**MASTER DRAINAGE STUDY
ADDENDUM NO. 2
Park Highlands West
(A.K.A. North Las Vegas 600-Acre Site)**

Subject: Addendum No. 2 to the Master Drainage Study for Park Highlands West (AKA North Las Vegas 600-Acre Site) - CNLV No. 46257

Re: Master Drainage Study for Park Highlands West (AKA North Las Vegas 600-Acre Site)
CNLV No. 46257

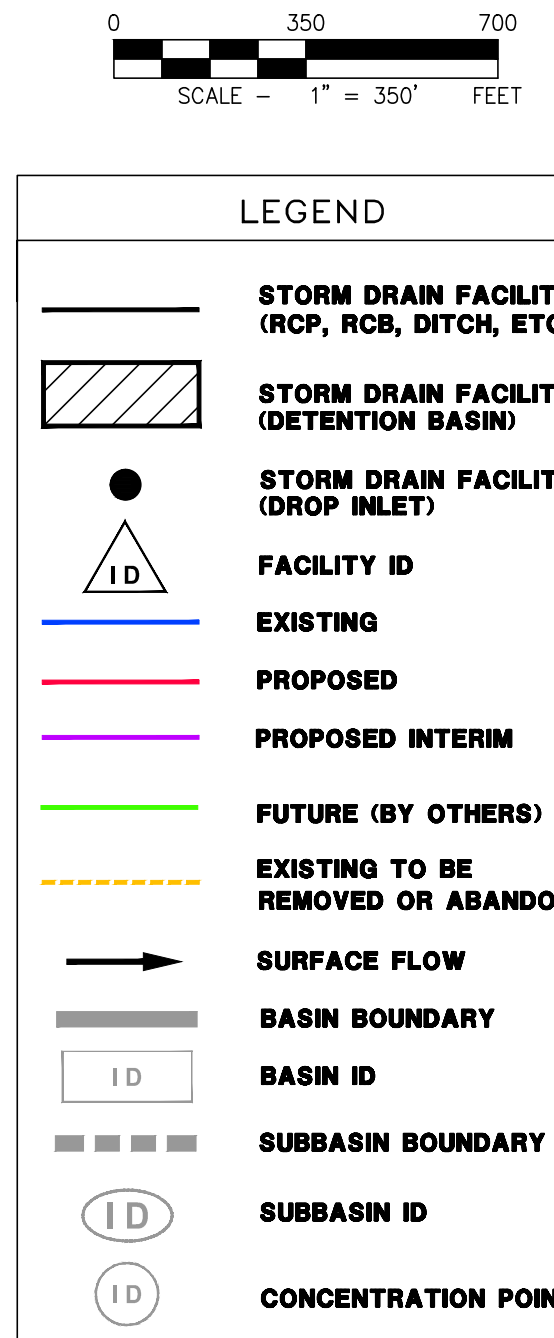
1. **Comment:** *Comment 14 has not been addressed. The proposed facility P73 directs urbanize runoffs toward the Conservation Transfer Areas which conflicts with the conditions specified within the Conservation Transfer Area Agreement. Please address by discussing and providing a plan to resolve the drainage issue on Grand Teton.*

Also, please discuss the issue regarding the construction of the north-half of Grand Teton at the location of the proposed facility P73;

2. **Comment:** *Various flow and HGL data on the Summary of Existing Stub and HGL table in response to Comment 15 appear to be in conflict with the data shown on the approved improvement plans. Particularly, please verify the Q per Detailed Analysis values for Facility ID E33, E54, E55, E57, E59, and E64. Also, HGL at Manhole values for Facility ID E52, E54, E59, and E69 are lower than the HGL shown at the manholes in the approved plans. Please discuss the discrepancies and revise the data accordingly;*

Response: Proposed Facilities P72 and P73 identification ID have been removed from Exhibit P. However, an extension of Facility P71 is depicted with a note indicating that the facility extension is part of the Park Highlands East (PHE) project and is conceptually addressed as part of that project Master Drainage Study. The proposed storm drain extension that remains on Exhibit P for the storm drain system in Grand Teton Drive east of Aliante Parkway now has the following note, "Proposed facility to be designed and constructed with Park Highlands East. Refer to the Master Drainage Study for Park Highlands East for storm drain facility description and conceptual facility sizing." The extension is depicted to show that there will be a facility to intercept the flows at the intersection and convey the flows east without impacting the Conservation Transfer Area. Per the January 27, 2014 meeting, the proposed Facility P72 bubbler was removed and a closed conduit extension of Facility 71 as part of the PHE project is now proposed. The replacement of the previously proposed bubbler (P72) and open channel (P73) with a closed conduit facility was considered an acceptable resolution to their concern regarding urbanized runoff discharge to the CTA. Revised Exhibit P has been provided in Appendix C for reference.

Response: The flow rates in the 'Q per Detailed Analysis' column for Facilities E33, E54, E55, E57, E59, and E64 have been corrected. As for the HGL, no changes have been made. Note that the HGL shown on the improvement plans were based on Standard Form 6 computations, which generally results in a conservative (a.k.a. higher) HGL. The elevation listed in the "HGL at Manhole" column for Facilities E52, E54, E59 and E69 are lower than the HGL shown on the improvement plans for two reasons: 1) the flows in the mainline or lateral had changed so new hydraulic models were provided which results in different losses in the storm drainage system (the new hydraulic model results replace the previous hydraulic models and established HGL) , and 2) the revised hydraulic computations were performed with WSPG which generally provides an HGL lower than Standard Form 6. The corrected table is provided on Exhibit P which is provided in Appendix C.

In reviewing the Summary of Existing Stub and HGL, the flow rate established by this MDS for Facilities E54, E55 and E94 are greater than the flow rate utilized in the technical design of the facilities. The increase in flow is believed to be negligible and the HGL remains more than 1-ft below finished grade. Therefore, the increases in flows for these facilities are considered acceptable.

SECTION 32 10-YR Worksheet for Irregular Channel

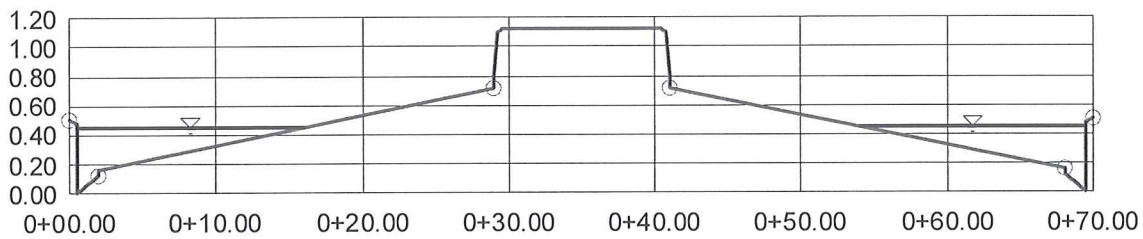
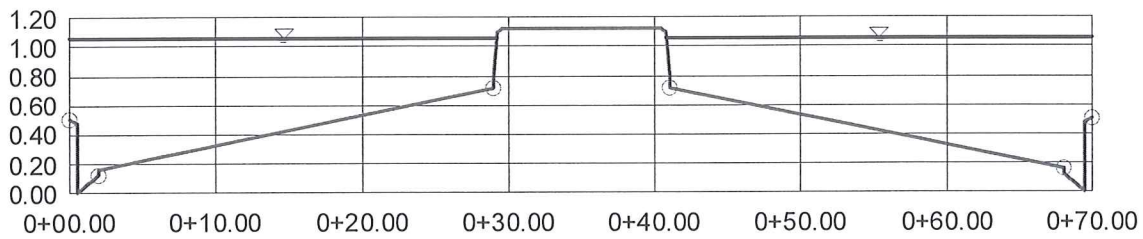
4. **Comment:** *Comment 18 has not been fully addressed. Please explain why the Engineer employed both the Rational Formula Method and the HEC-1 analysis to determine the flow rates. If the Rational Formula Method is being used to determine the flow rates in the onsite streets, then please ensure that all onsite streets are delineated as drainage basins so that accurate onsite street flows could be obtained;*

In response to this comment and reviewing Exhibit O, it was determined that an additional cross section is required which results in an additional subbasin to be assessed with the rational method. Cross Section 32 has been incorporated onto Exhibit O which is located in Appendix C. The hydrologic and hydraulic computations associated with the cross section are included in Appendix D and E, respectively.
